**ENVIRONMENTAL
RESTORATION
PROJECT**

**SUBJECT: SUBMITTAL OF REVISED REQUEST FOR CLASS 1 CLOSURE PLAN
MODIFICATION FOR MATERIAL DISPOSAL AREA (MDA) P
LOS ALAMOS NATIONAL LABORATORY NM0890010515
TASK NO. HWB-LANL-01-030**

**Response to
Revised Request for Class 1 Closure Plan Modification,
for Material Disposal Area P (MDA P),
Los Alamos National Laboratory NM0890010515,
Task Number HWB-LANL-01-030**

Figure 1-1, part of
MDA P closure plan
replacement pages
May 2002
LA-UR-02-2749

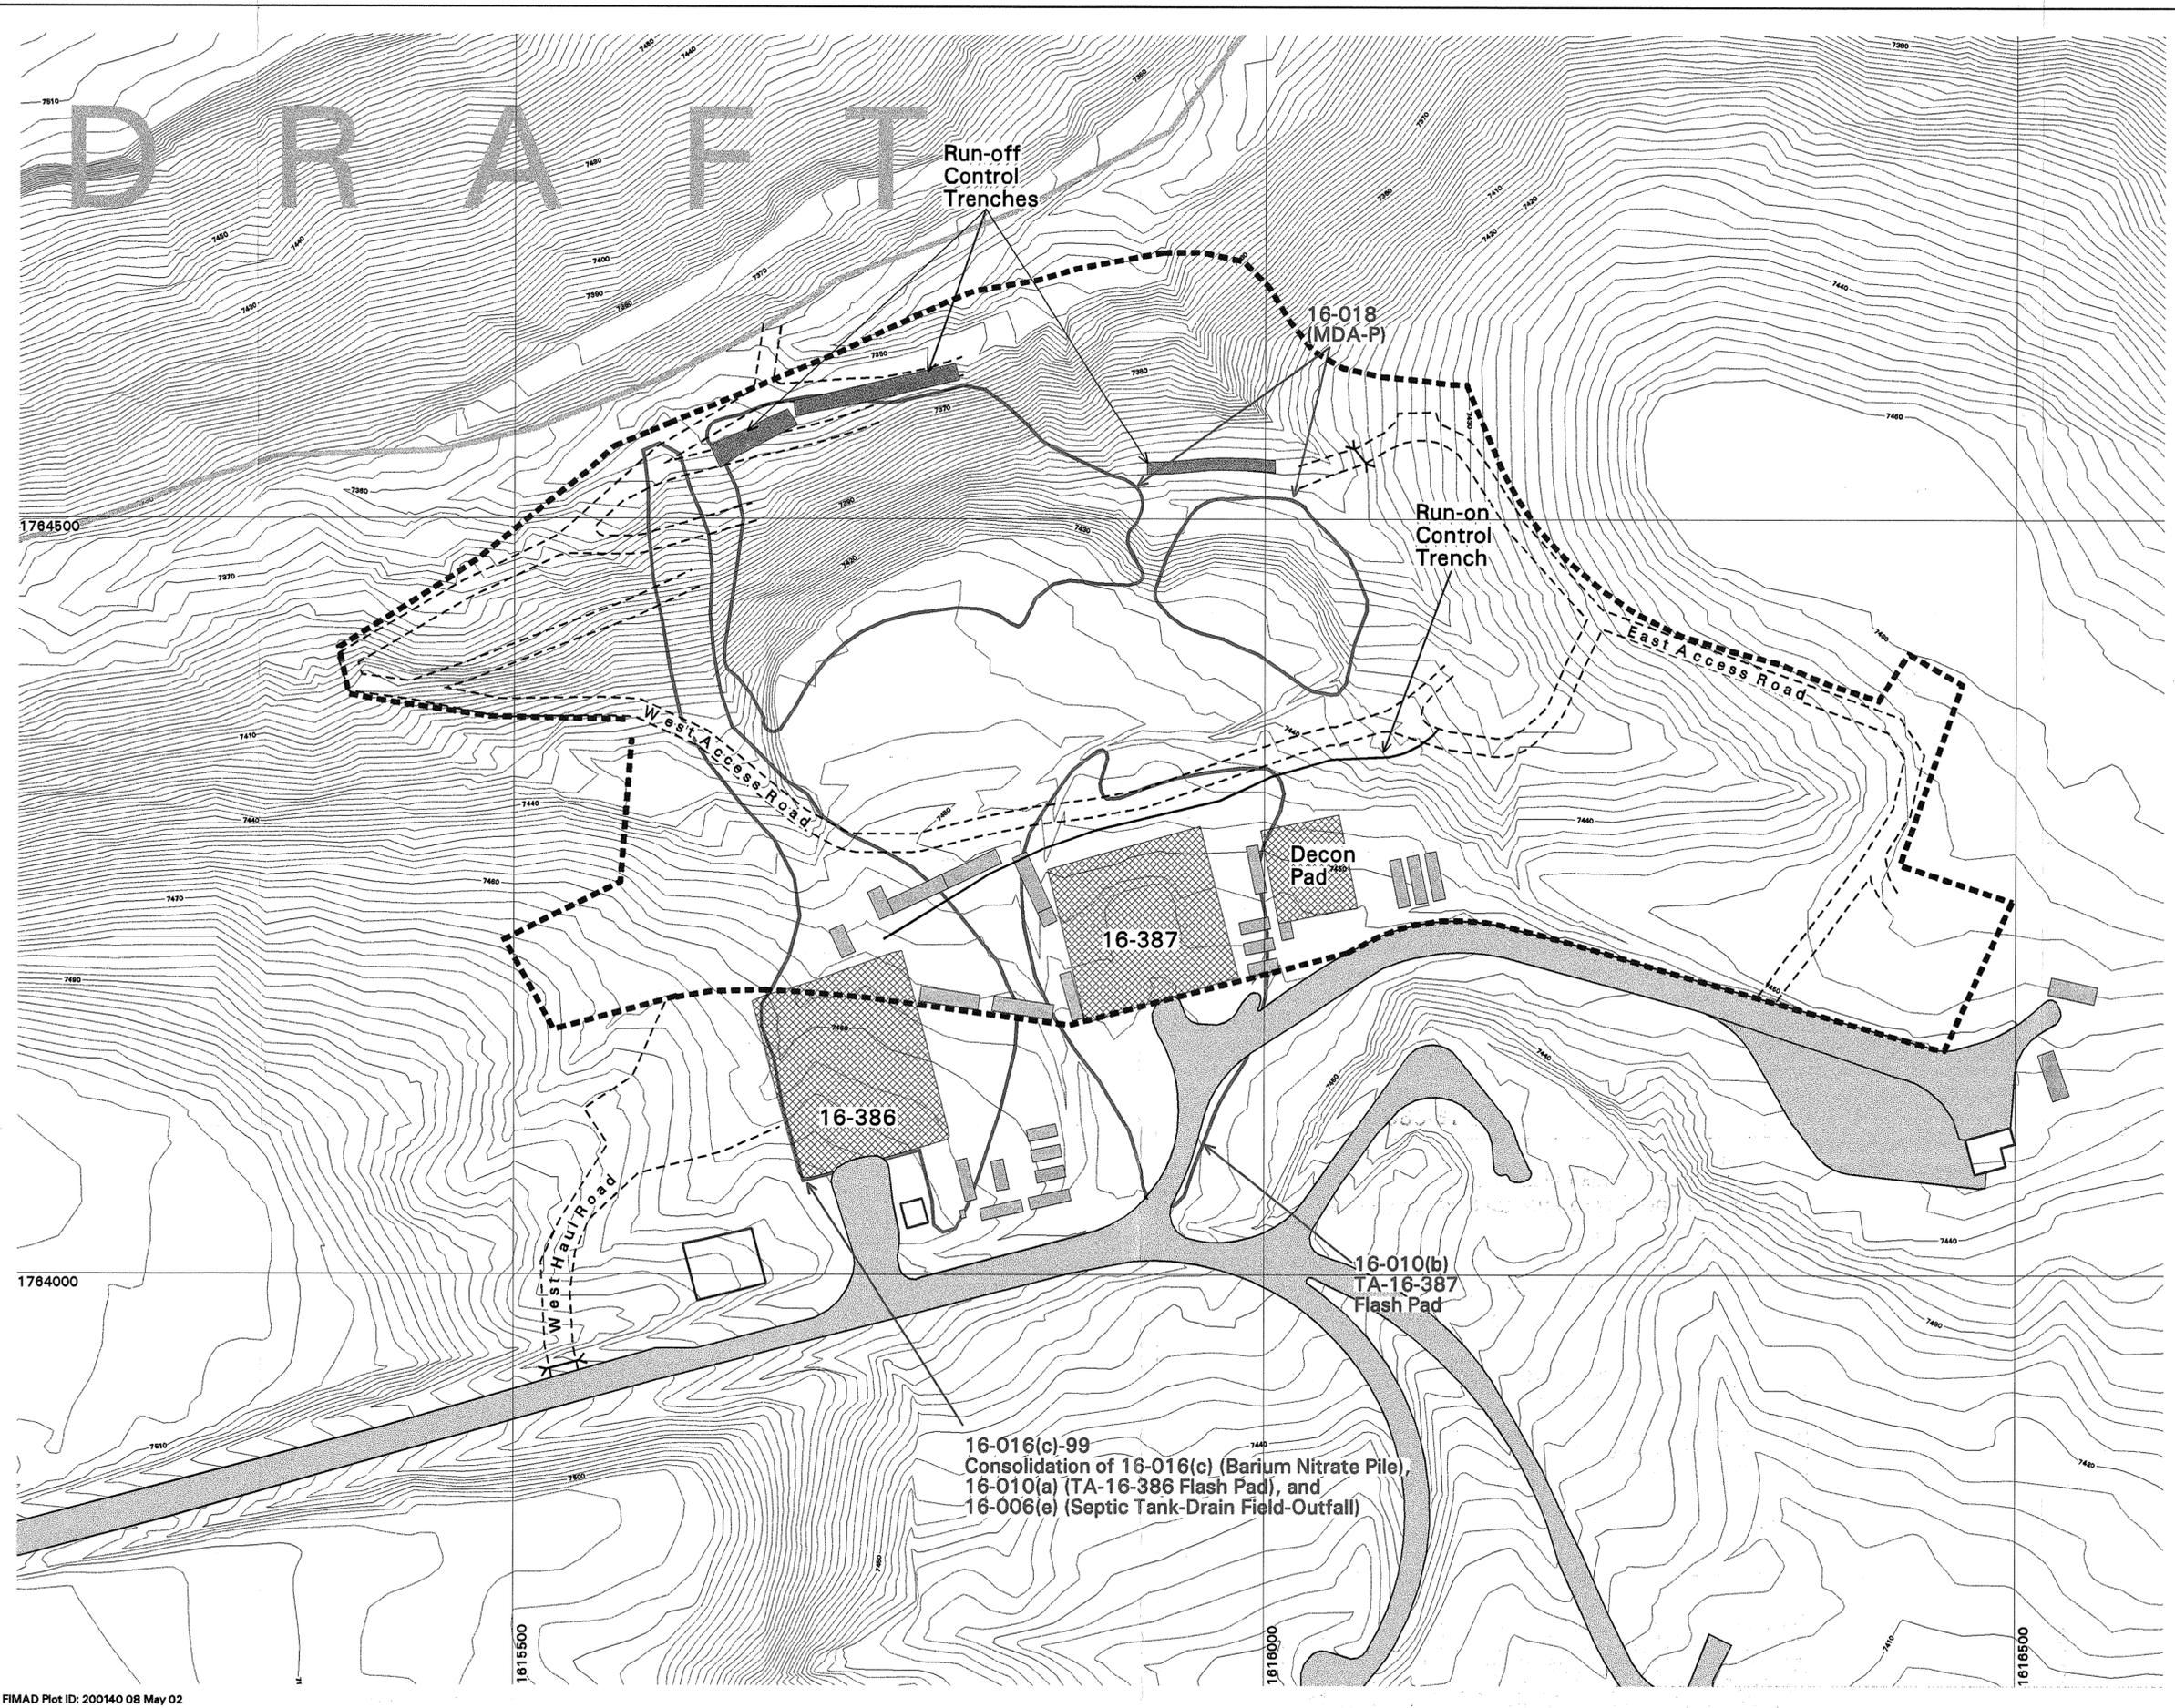
4. *Page 1-2 of the modification request corrects a typographical error in the approved closure plan for MDA P. This page may be resubmitted with the revised closure plan modification.*

4. Enclosed is replacement page 1-2 as well as a map (Figure 1-1).
